addendum no. 01

date: 11/16/2026

project name: Millard Public Schools – Millard North High School Theatrical Lighting Upgrade

project no: 26319

SECOND FLOOR - LIGHTING PLAN

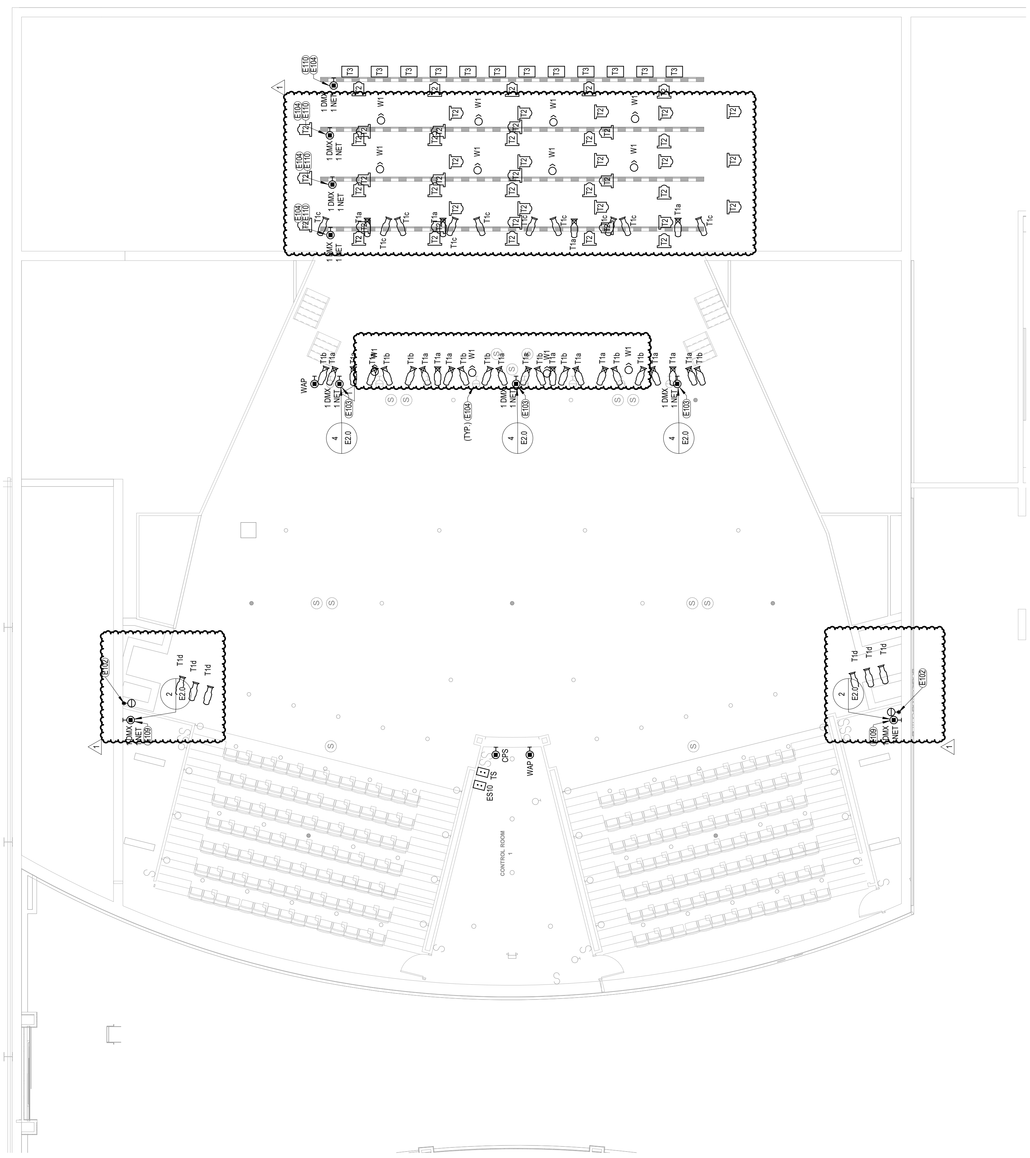
1. Sheet E1.1 – SECOND FLOOR – LIGHTING PLAN
    a. Added six (6) new type T1d ellipsoidal fixtures (ETC ColorSource Spot V with 10 degree barrel) at the front of house lighting positions, three (3) at each side of the house.
    b. Added two (2) new surface mount plug boxes with two stage pin receptacles at the front of house lighting positions, one (1) at each side of the house. Refer to keynote E102, which has been added to the sheet keynotes.
    c. Added thirty (30) new type T2 Fresnel fixtures to the first, second and third onstage electrics.
    d. Added twelve (12) new type W1 worklights: four (4) at the downstage lighting position and four (4) each on the second and third onstage electrics.

ELECTRICAL SCHEDULES & DETAILS

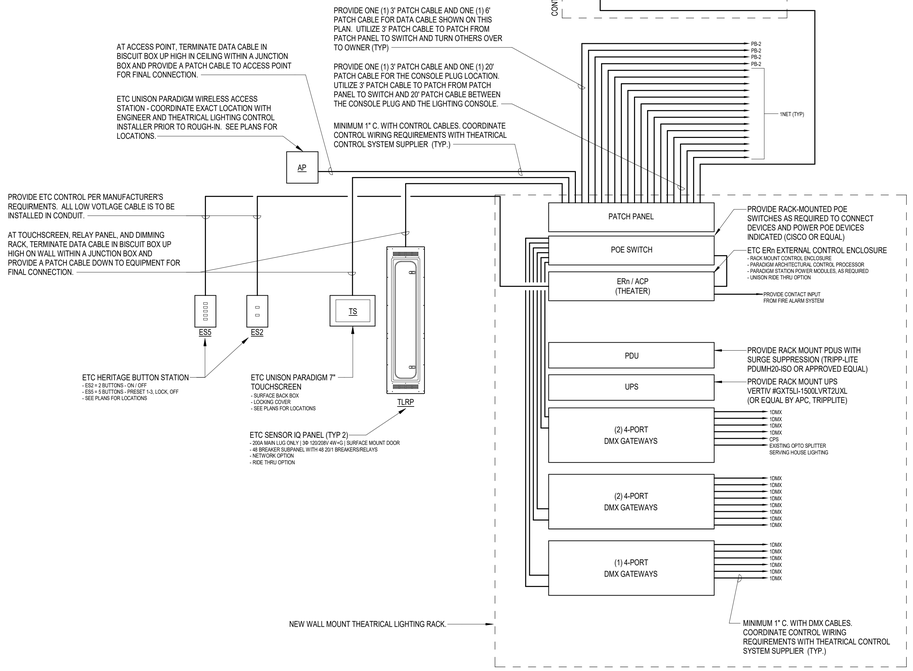
2. Sheet E2.0 – ELECTRICAL SCHEDULES & DETAILS
    a. Luminaire Fixture Schedule: Added fixture type T1d – Ellipsoidal, 10 degree; ETC ColorSource Spot V – 10 degree barrel; RGBIL LED; 197 W; 120 V; black finish; C-clamp mount.
    b. Luminaire Fixture Schedule: Added fixture type W1 – Worklight; SSRC WL-LED-150-W; LED; 120 V; black finish; C-clamp mount.
